**Environmental Impact Statement (EIS) assessment report  
under the *Environmental Protection Act 1994***

Central Queensland Coal

proposed by Central Queensland Coal Pty Ltd and  
Fairway Coal Pty Ltd

Prepared by: Environmental Impact Assessment, Department of Environment and Science

**Figure 6 Groundwater drawdown contours**

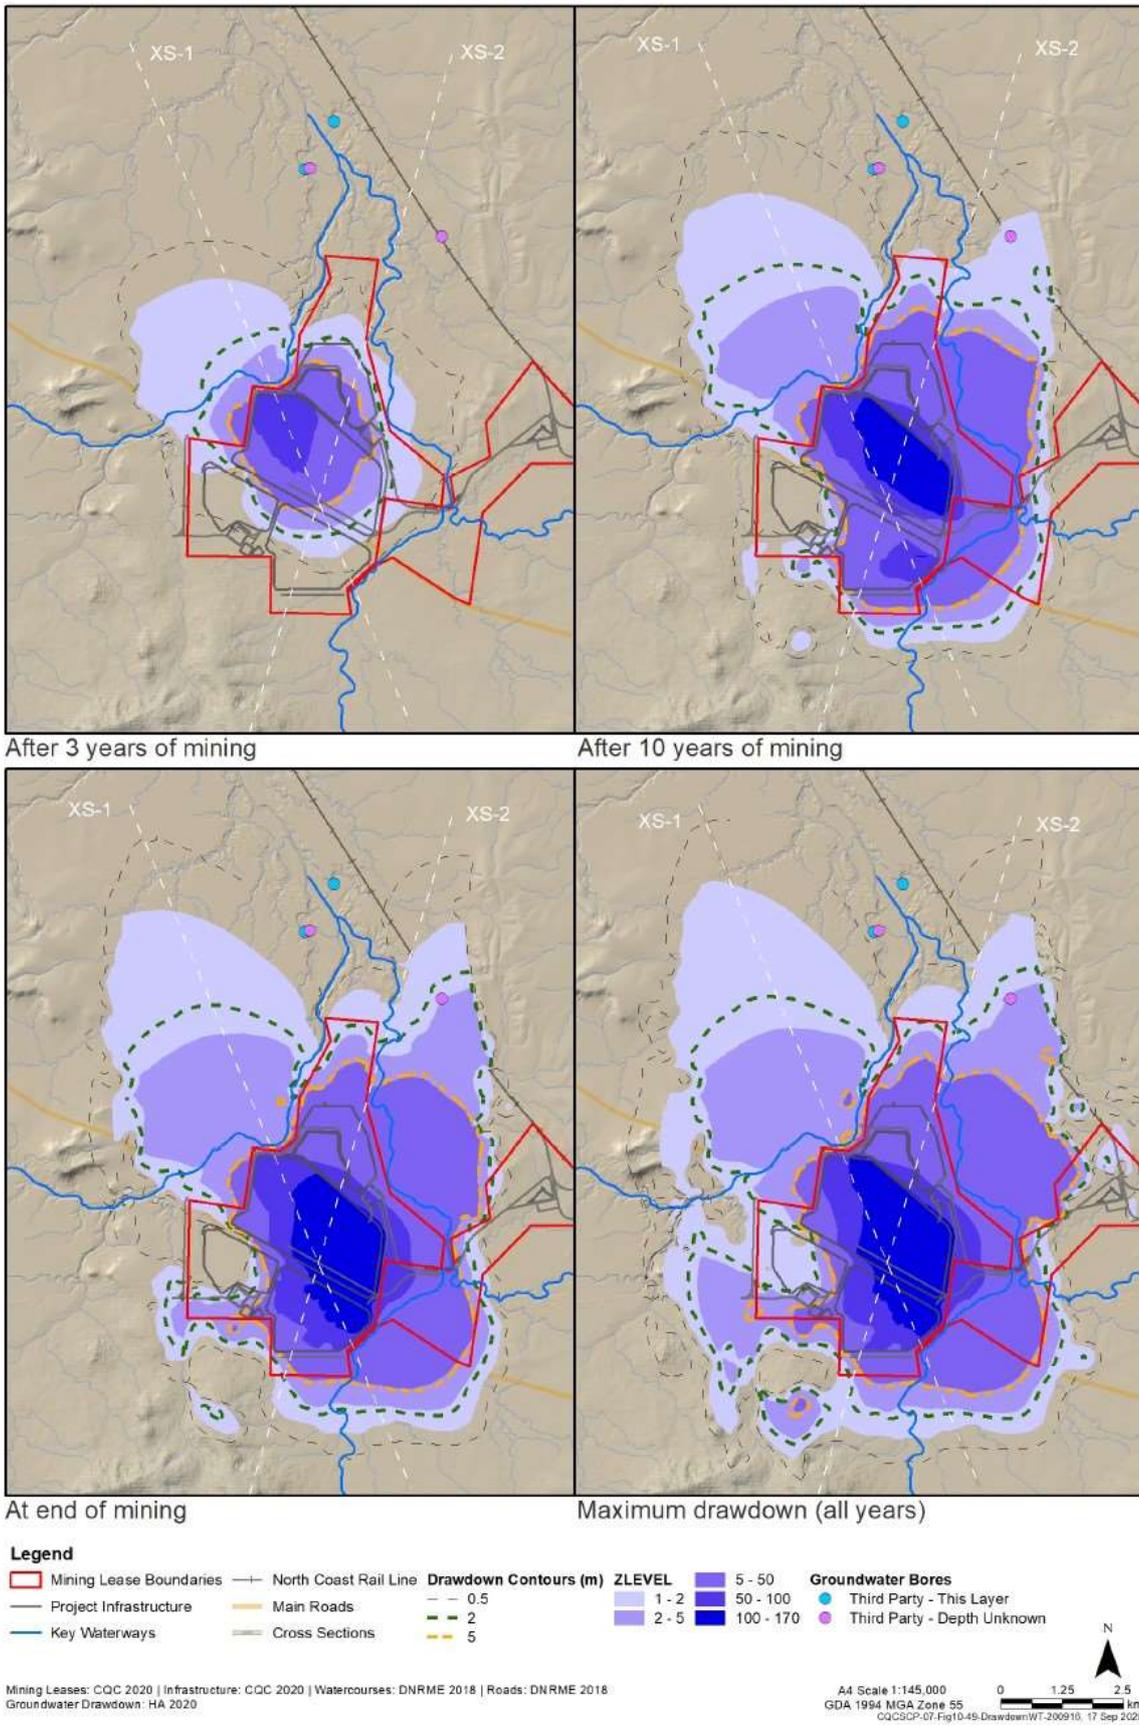
Revised assessments in the amended EIS informed by a new regional groundwater model stated that groundwater drawdown impacts to Tooloombah Creek and Deep Creek would not significantly impact fish habitat values. Observed pools persistence and water quality data indicate that the primary source of baseflow to pools is from bank storage return. Impacts on Tooloombah Creek are expected to be minor due to the predicted drawdown (less than 4m), low permeability sediments reducing the potential for enhanced leakage, flows from bank storage sustaining some pools, and natural resilience of ephemeral pools (particularly on Deep Creek) already experiencing natural drying cycles under baseline conditions.

**Figure 11 GDE vegetation subject to groundwater drawdown impacts**

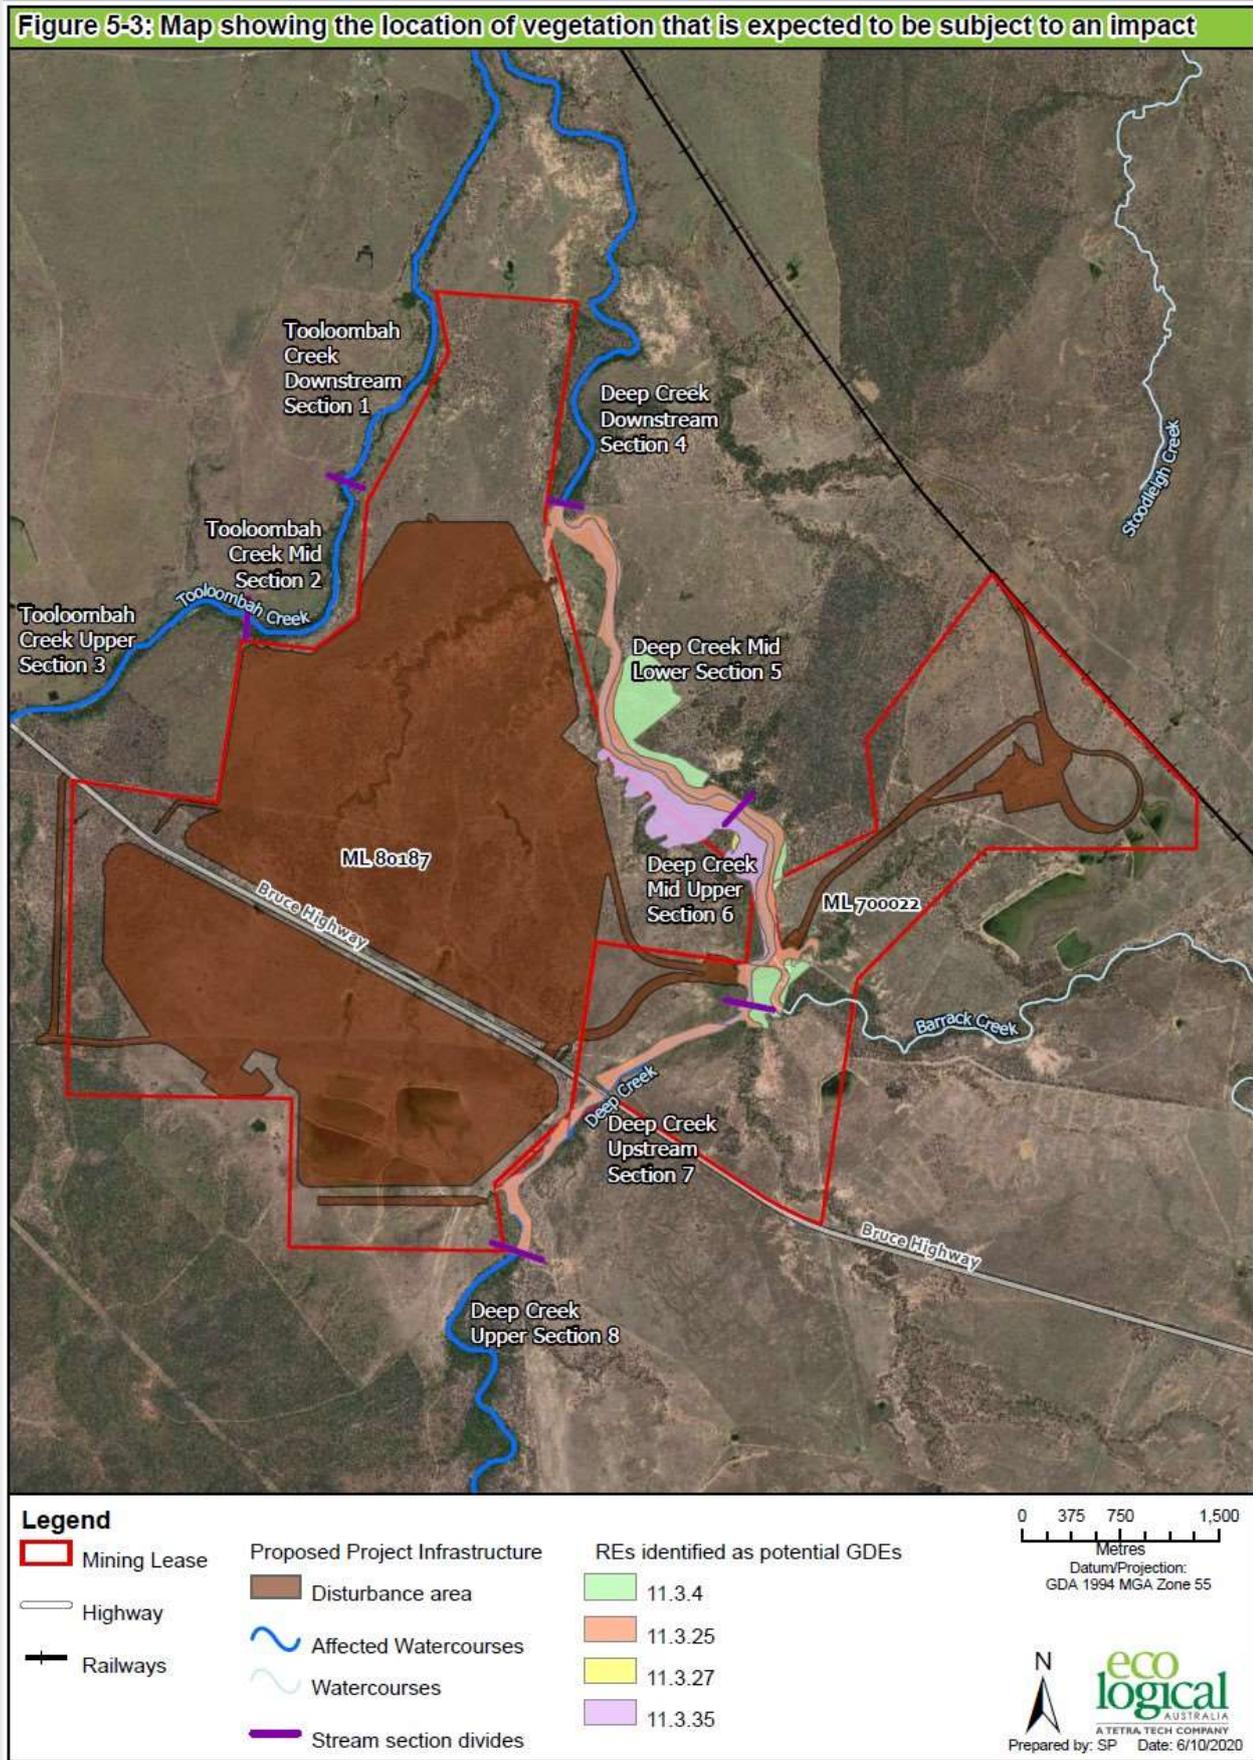
The EIS concluded that 165ha of riparian vegetation along Deep Creek would be subject to minor impacts from the lowering of the water table. The predicted vegetation communities subject to impact comprise RE 11.3.4, RE 11.3.12, RE 11.3.25, RE 11.3.27, RE 11.3.35 where they are accessing groundwater located less than 15mbgl and that groundwater has an EC less than 10,000  $\mu\text{S}/\text{cm}$ . Potential impacts to terrestrial GDEs include loss of condition and structural elements such as dieback of some large trees that may result in stream bank instability, erosion and consequential impacts to instream aquatic ecology values as well as to the downstream receiving environment. Impacts to riparian vegetation are expected to occur 10 to 20 years after commencement of the project. See GDE vegetation subject to groundwater drawdown impacts.
